### ADDENDUM 1

## Austin Elementary School Heating & Air Condition (HVAC) Improvements Funded through the Elementary & Secondary Emergency Relief (ESSER) Funds May 31, 2022

## Addendum

**PROJECT** 218007.004 | Edinburg CISD - Stephen F. Austin ES - HVAC Improvements

DATE:	05/05/2022
DRAWN BY:	DBR
CHECKED BY:	DBR
PROJECT NUMBER:	218007.004
SHEET TITLE:	LEVEL 1 MECHANICAL PLAN-CAFETERIA-KITCHEN - DEMOLITION
SHEET NUMBER:	MD2.13

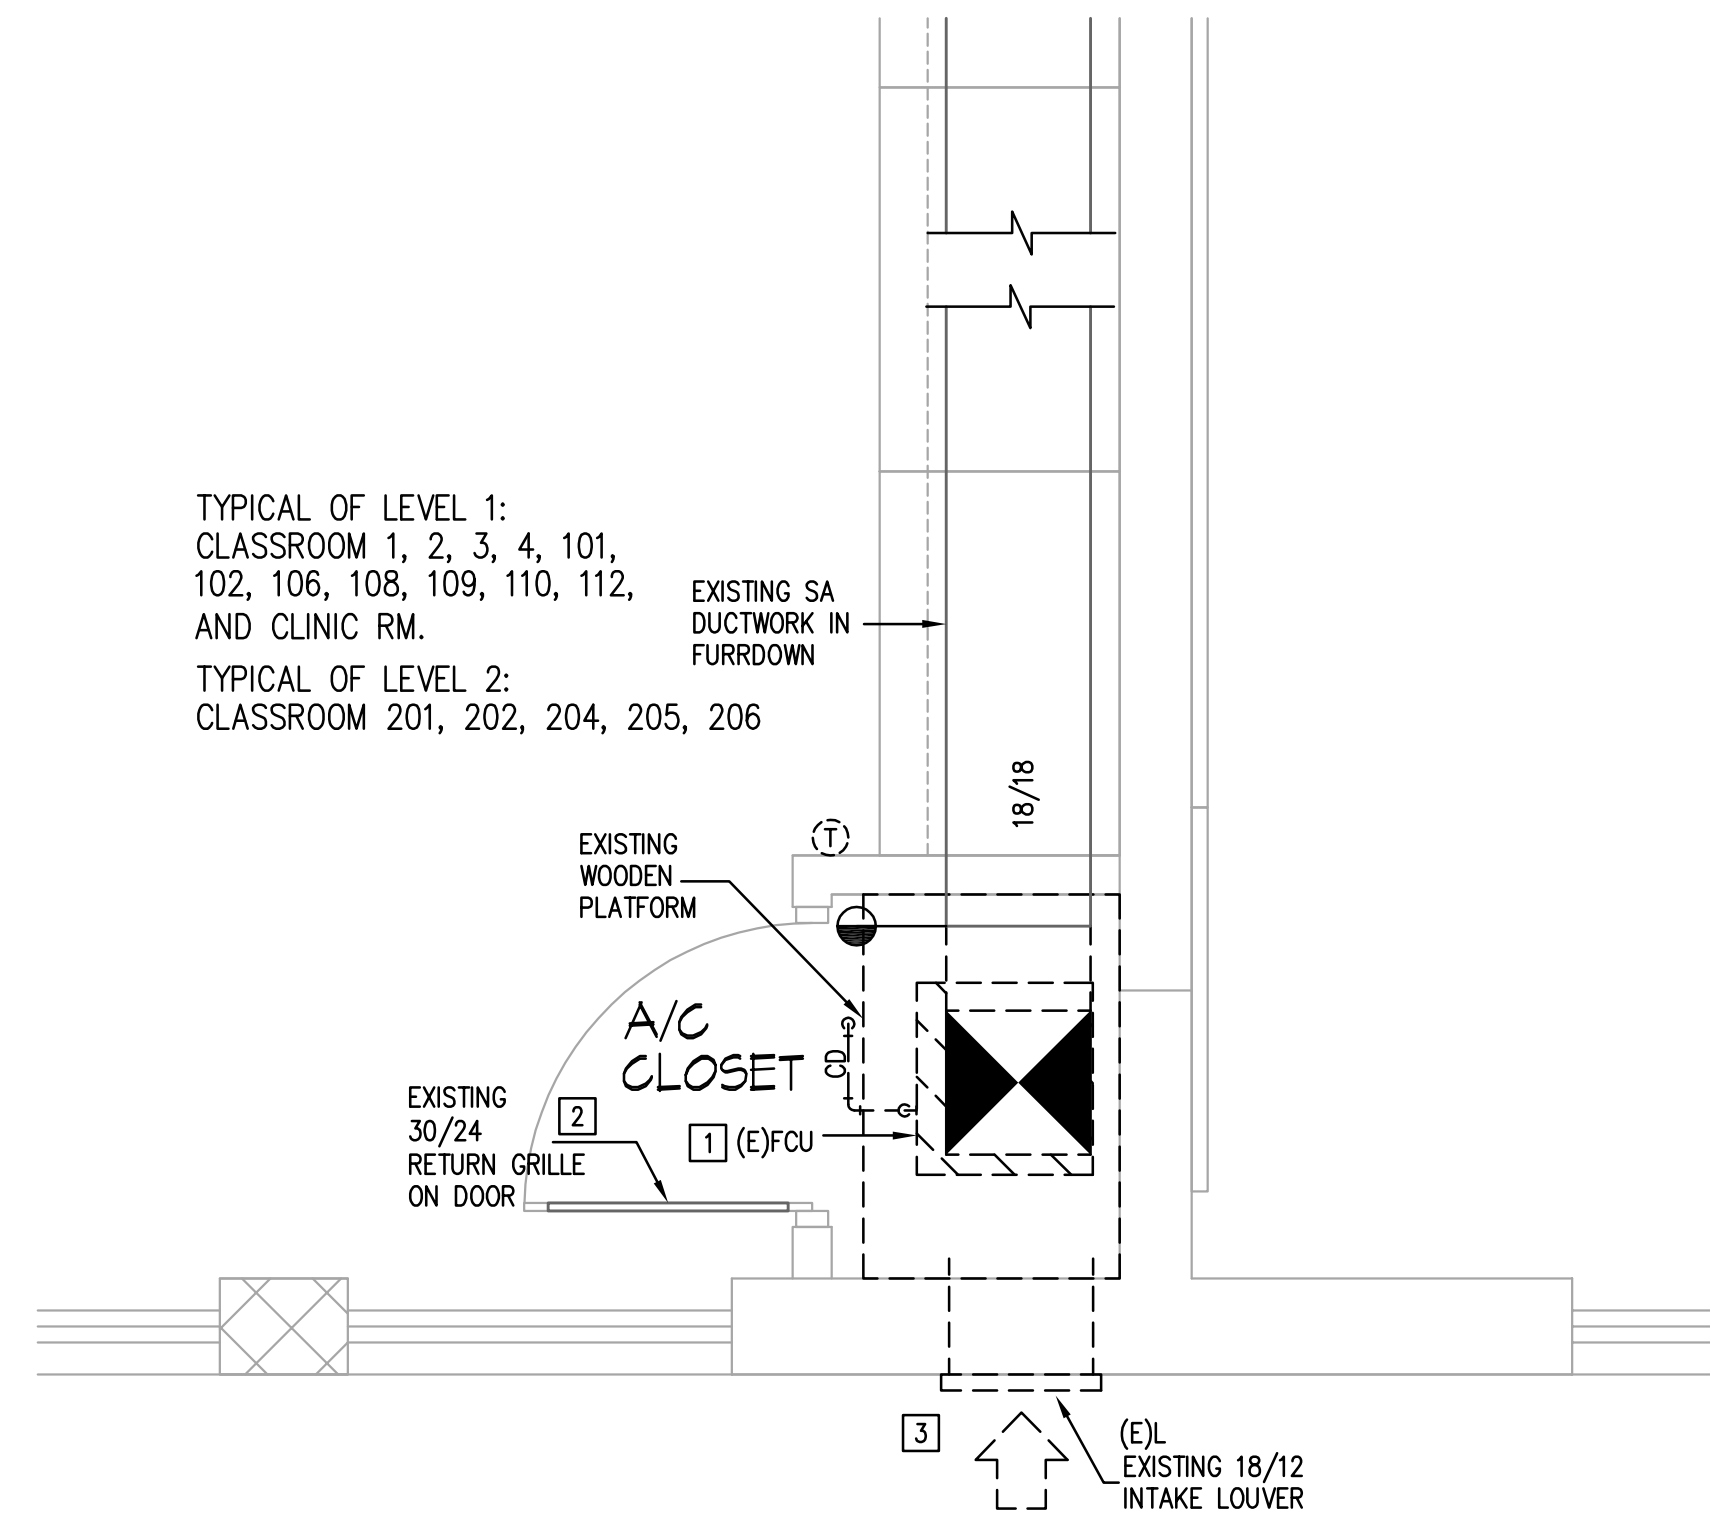
#### **Item 03 Sheet MD2.13 – Level 1 Mechanical Plan – Cafeteria-Kitchen - Demolition**

- A. Revised keyed notes 2 and 3.

SHEET NUMBER:  
**MD3.01**

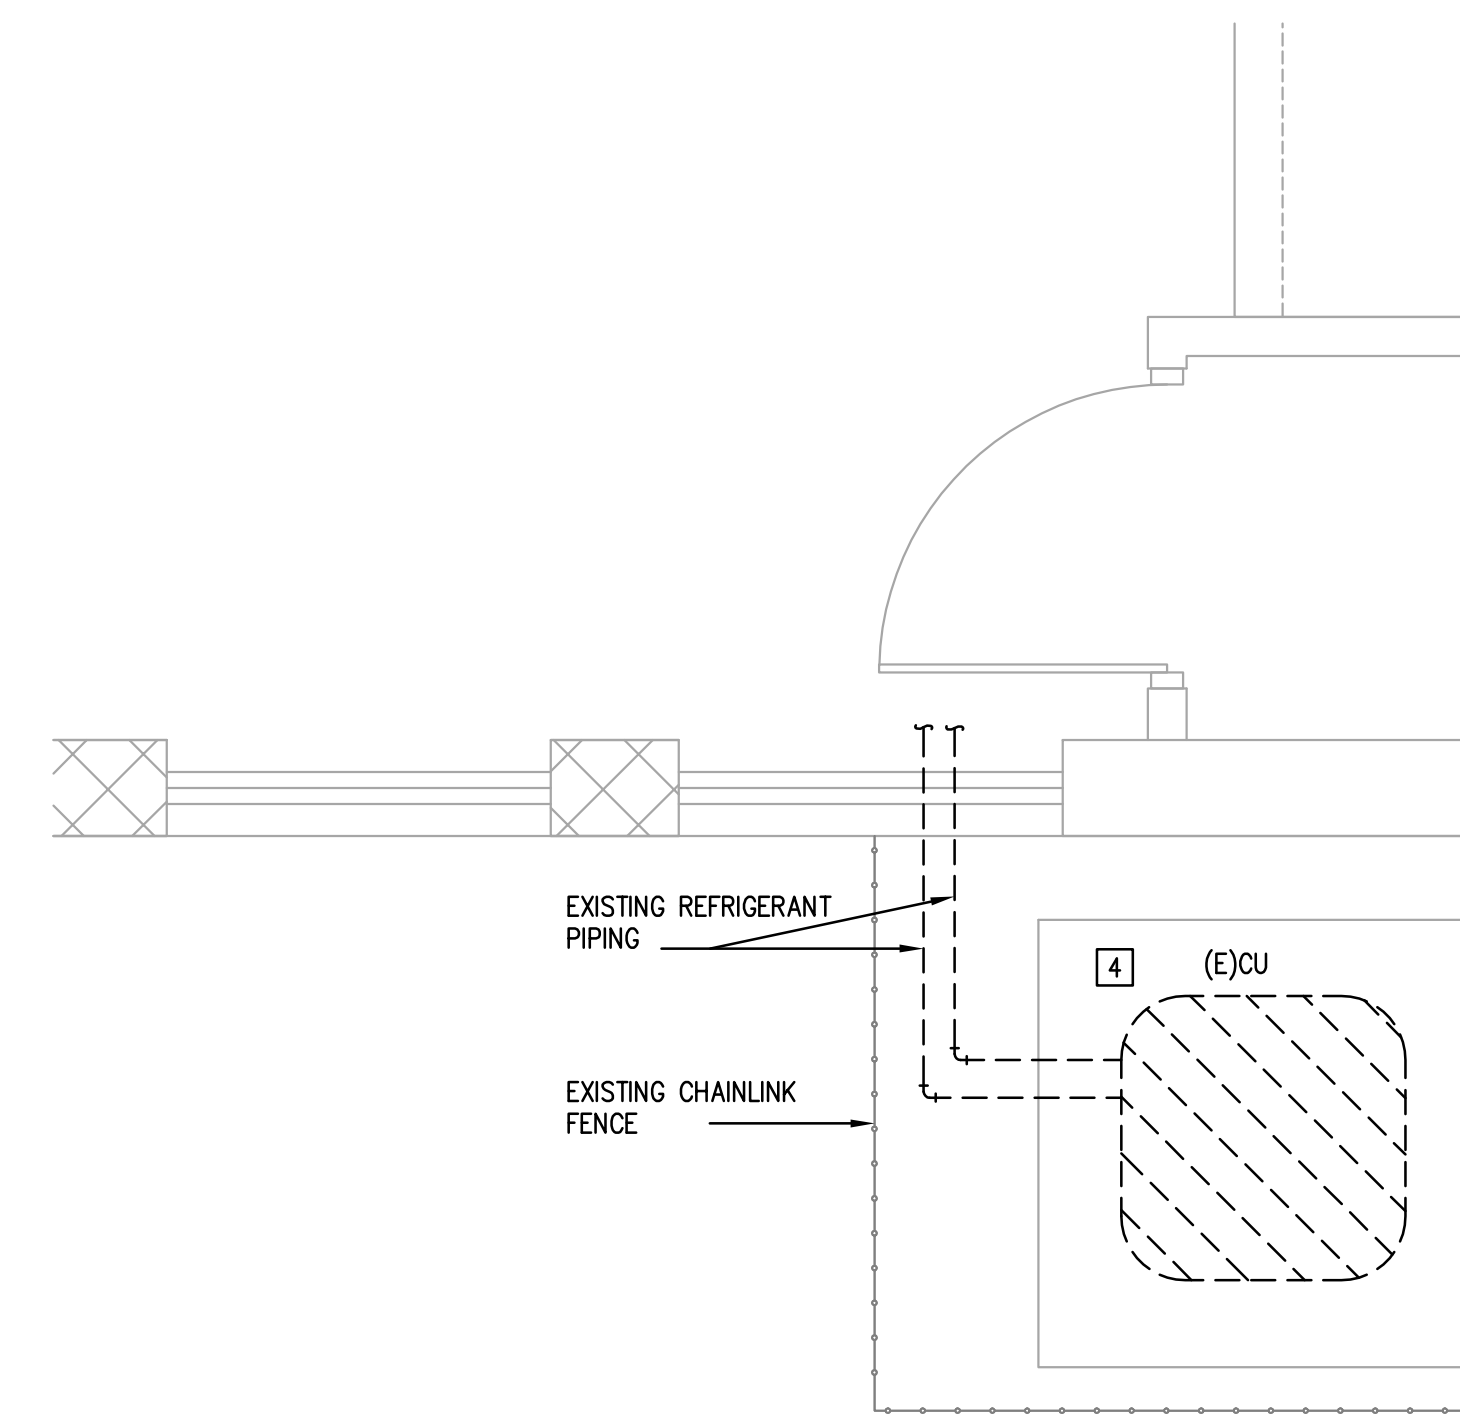
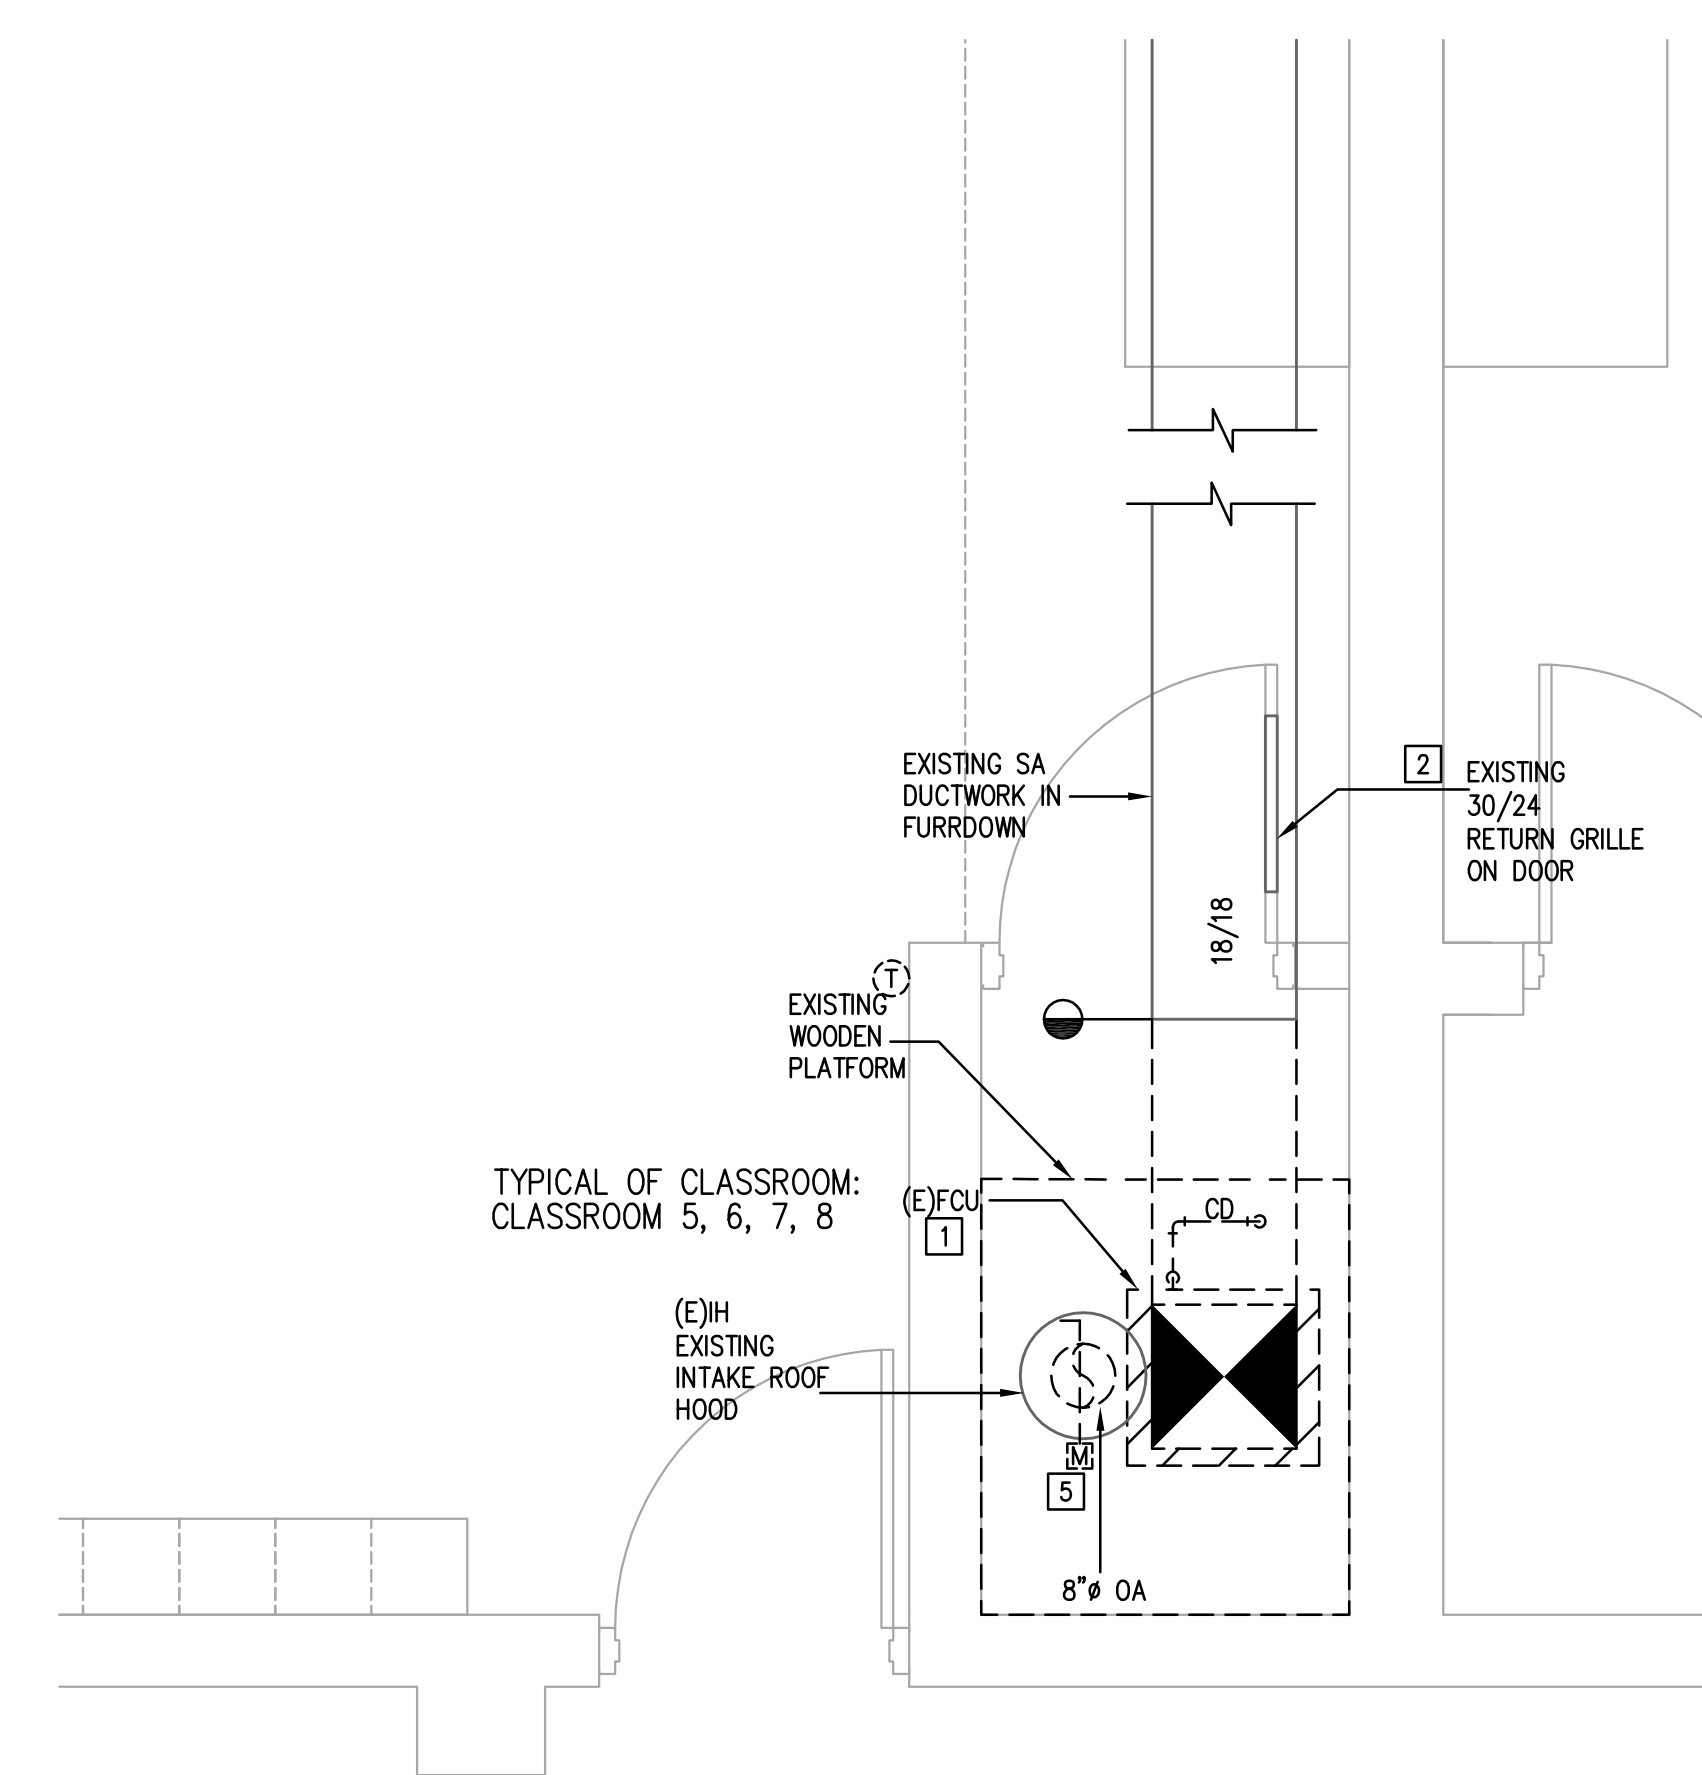
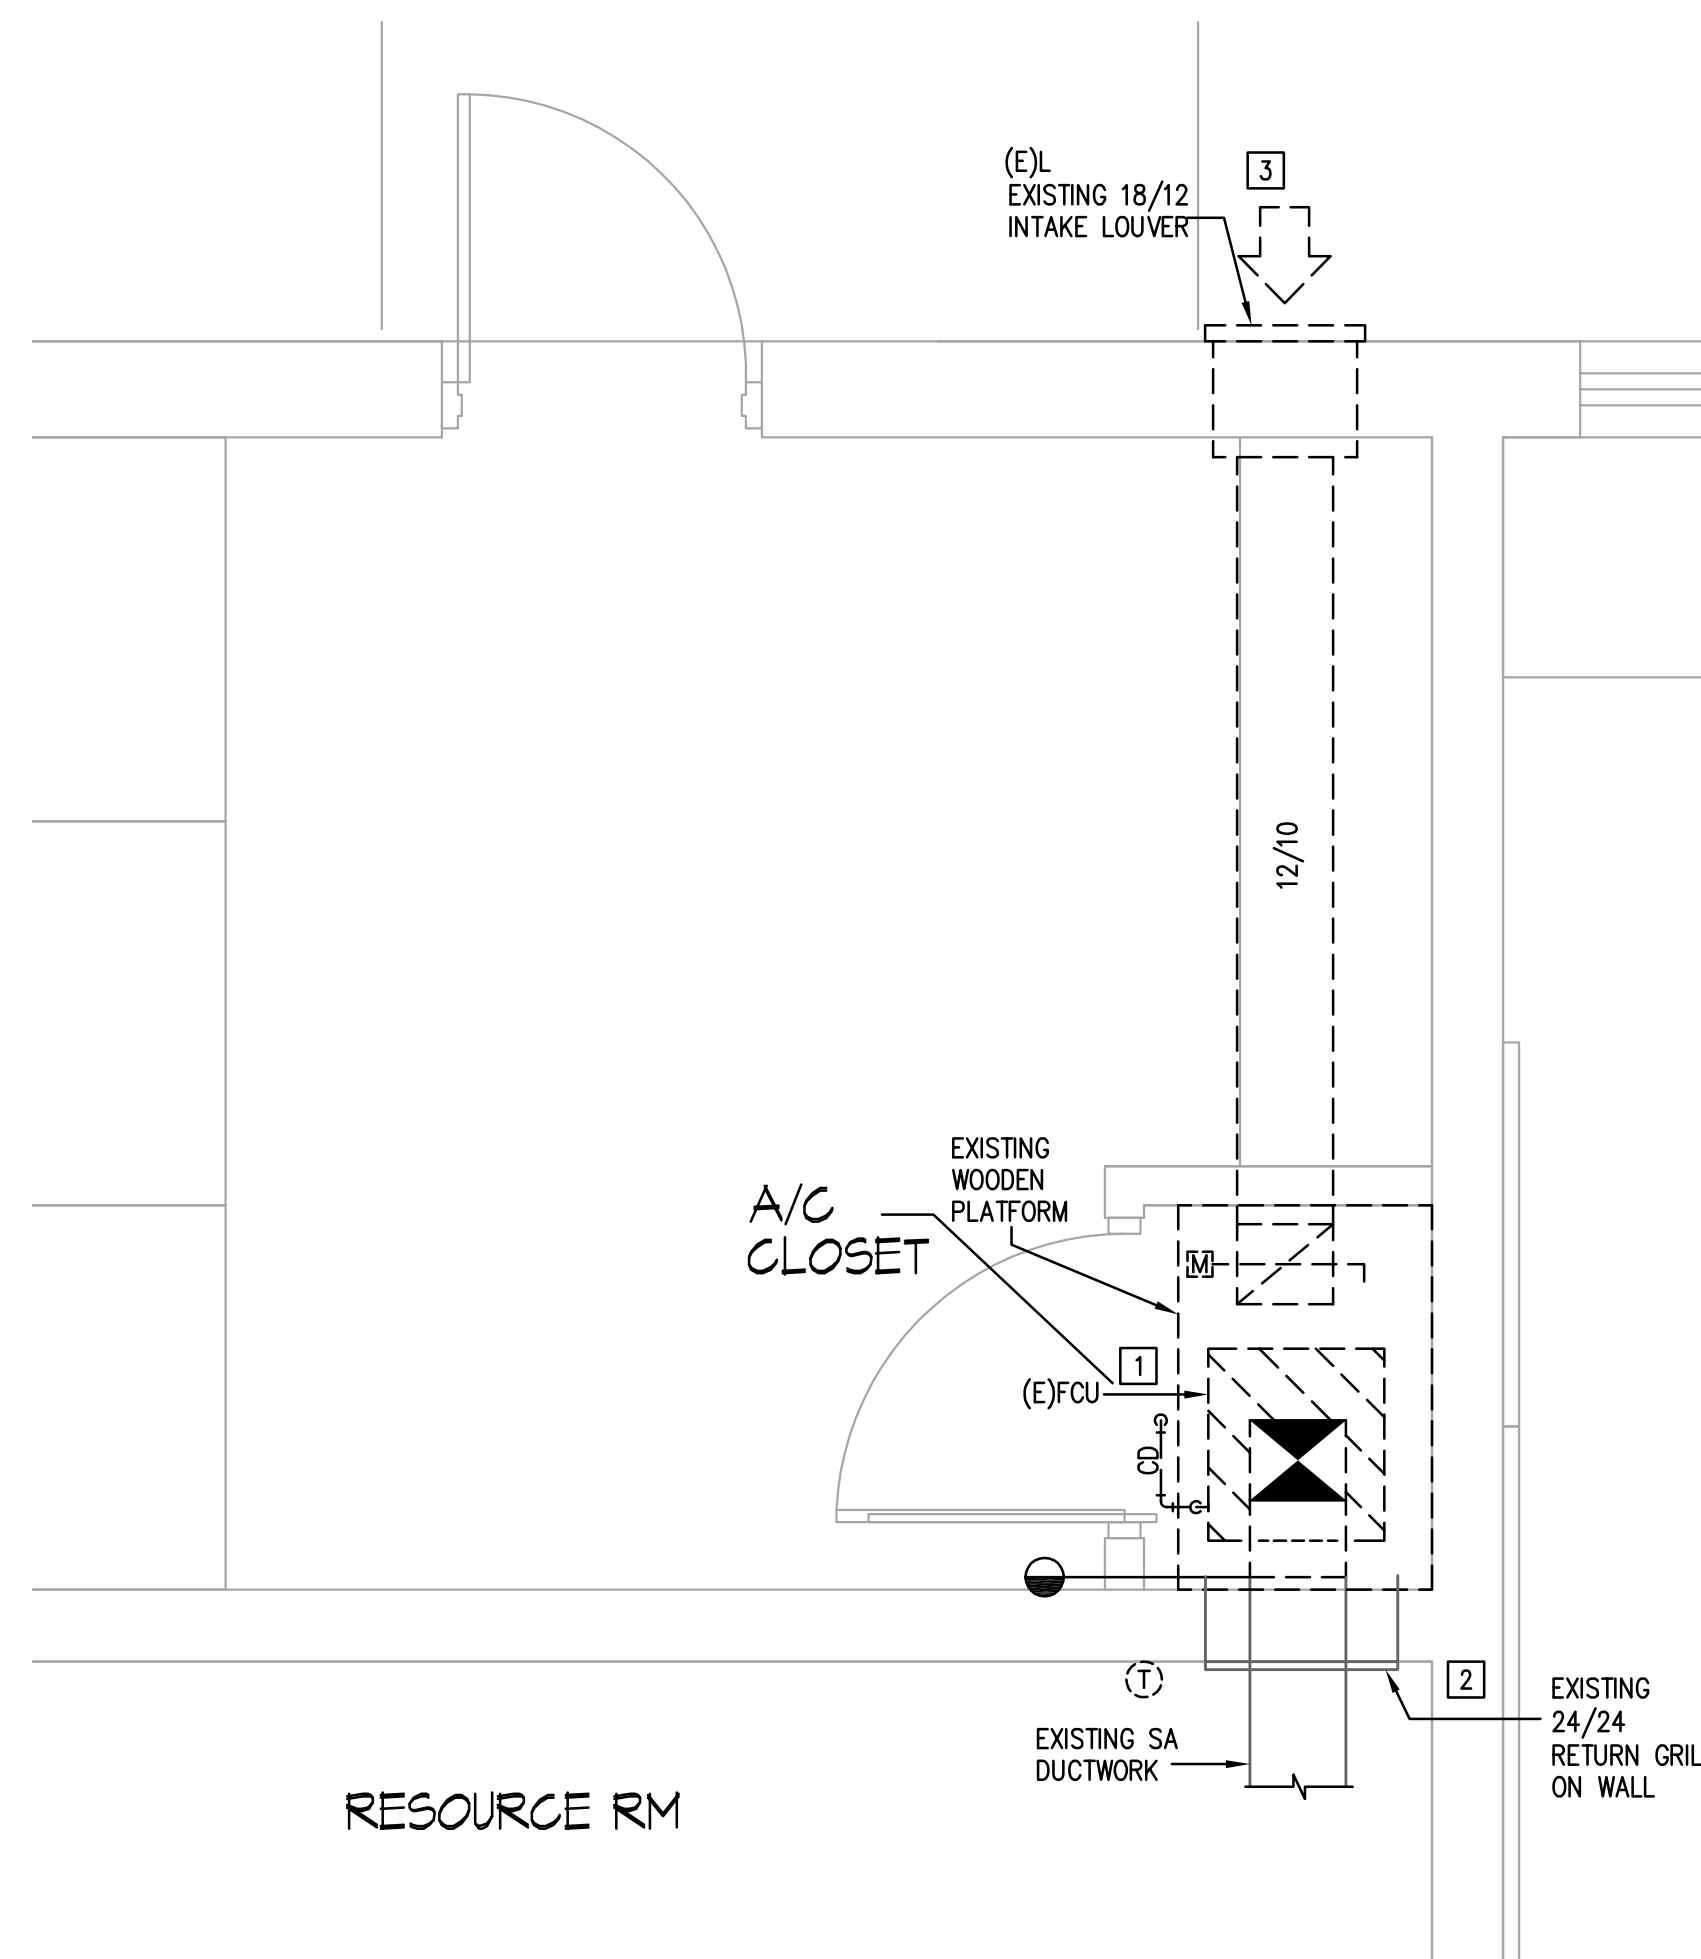
#### **Item 04 MD3.01 – Enlarged Mechanical Plans – Demolition**

- A. Revised keyed notes 1, 4, and 6.
